Model: Adonis-C1 (Scanner Option)		Date: 05-Apr-00	No.: RA283001
Subject: Service Manual Correction		Prepared by: K. Takagi	
From: Technical Services Dept., GTS Division			
Classification:	<input type="checkbox"/> Troubleshooting <input type="checkbox"/> Part information <input type="checkbox"/> Action required <input type="checkbox"/> Mechanical <input type="checkbox"/> Electrical <input checked="" type="checkbox"/> Service manual revision <input type="checkbox"/> Paper path <input type="checkbox"/> Transmit/receive <input type="checkbox"/> Retrofit information <input type="checkbox"/> Other (      )

Model: Adonis-C1		Date: 26-Apr-00	No.: RA283002
Subject: ROM History (Adonis-C Fax Option)		Prepared by: M. Mano	
From: Technical Services Dept., GTS Division			
Classification:	<input type="checkbox"/> Troubleshooting <input type="checkbox"/> Part information <input type="checkbox"/> Action required <input type="checkbox"/> Mechanical <input type="checkbox"/> Electrical <input type="checkbox"/> Service manual revision <input type="checkbox"/> Paper path <input type="checkbox"/> Transmit/receive <input checked="" type="checkbox"/> Retrofit information <input type="checkbox"/> Other (

#### November 2000 Change:

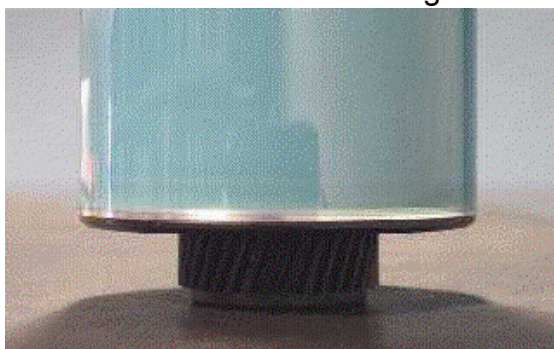
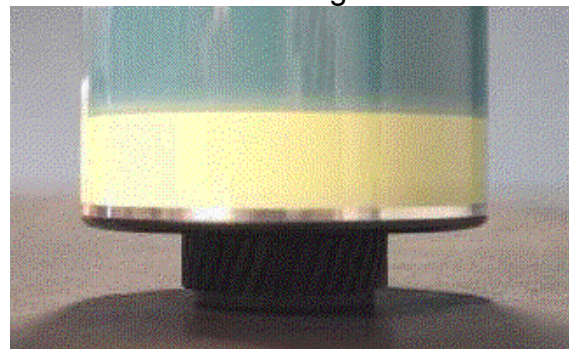
The photo-conductive CGL layer is not applied to an area 14 mm from one end of the drum edge (see photographs below). This area is outside the image writing area. Tests on the prototypes confirmed that there was no change in performance or quality between the two drums, and therefore no effect on image quality.

The following picture can be used to visually distinguish between drums from November 2000 production and those from before/after:

During November 2000, the efficiency of the new drum production process was reconfirmed. Although there were no quality problems with the drum itself, the process efficiency was not improved as much as previously expected and it was changed back to the previous method in December.
